SUBJECT: Transmittal of Changes to Emergency Plan Implementing Procedures (EPIP)

Confirmation of Transmittal for
Emergency Planning Documents/Information

EPIP-EOF-7

Title: PROTECTIVE ACTION GUIDELINES

Attachment 6.1 - Protective Action Recommendations Flowchart
Based on Plant Conditions and Radiological Data

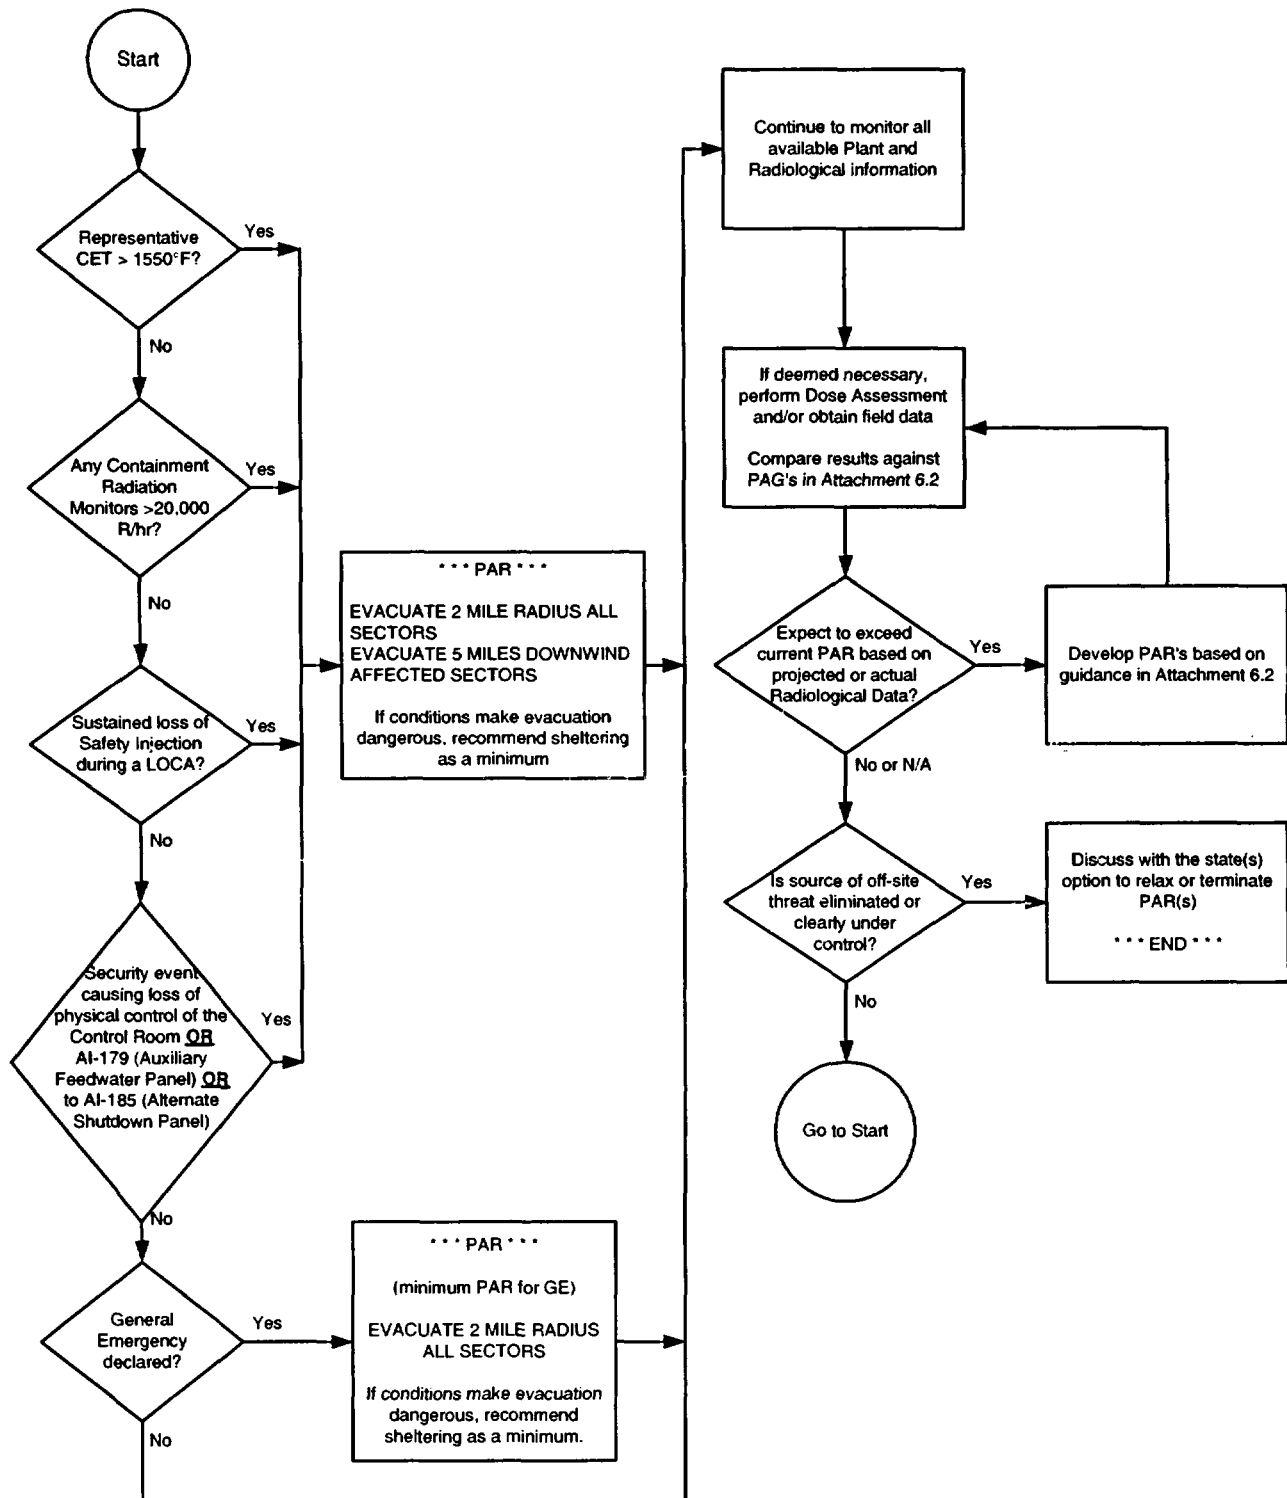
Reason for Change: Delete reference to sub-areas 1-10 in note and in recommended PAR section, because OPPD does not recommend PAR's based on sub-areas.
